Registry No. H-10970

General Locality Puget Sound

Descriptive Report to Accompany Hydrographic Survey H10970

Project OPR-S-N907-RA-00
Lake Washington Ship Canal
Scale 1:5000
March 2000

Chart 18447
28th Ed., January 25, 1997
Revisions from NOAA Hydrographic
Survey H10970
Soundings in feet at LOW WATER OF LAKE

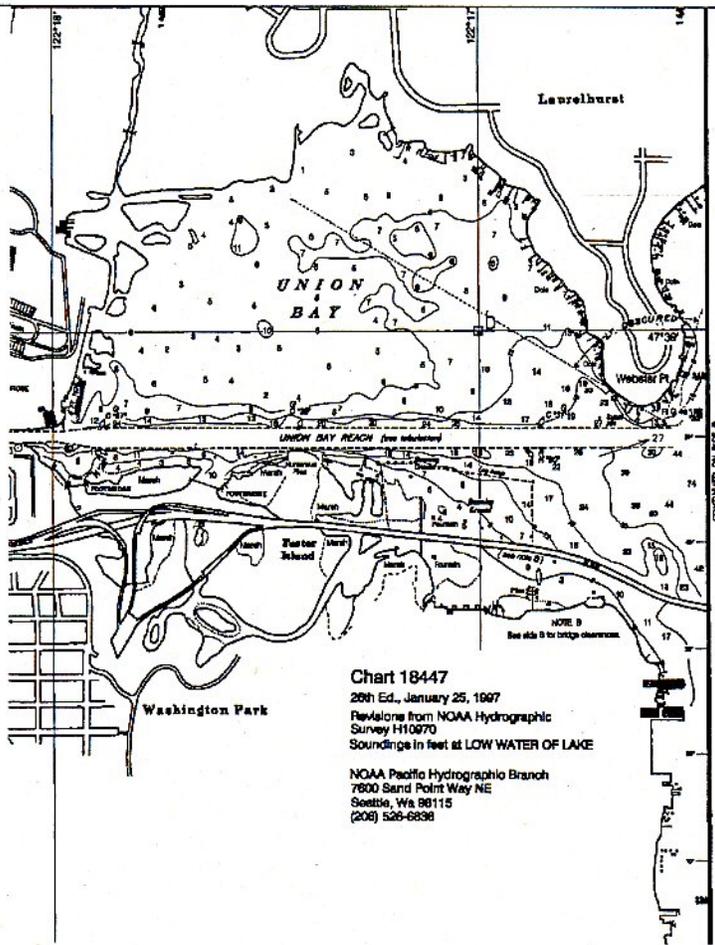
<u>Feature</u>	<u>Depth</u>	<u>Latitude</u>	<u>Longitude</u>
sounding	27 ft	47/38/49.7 N	122/16/35.2 W

A shoal sounding of 27 feet within the Union Bay Reach Channel in a controlling depth of 30 feet.
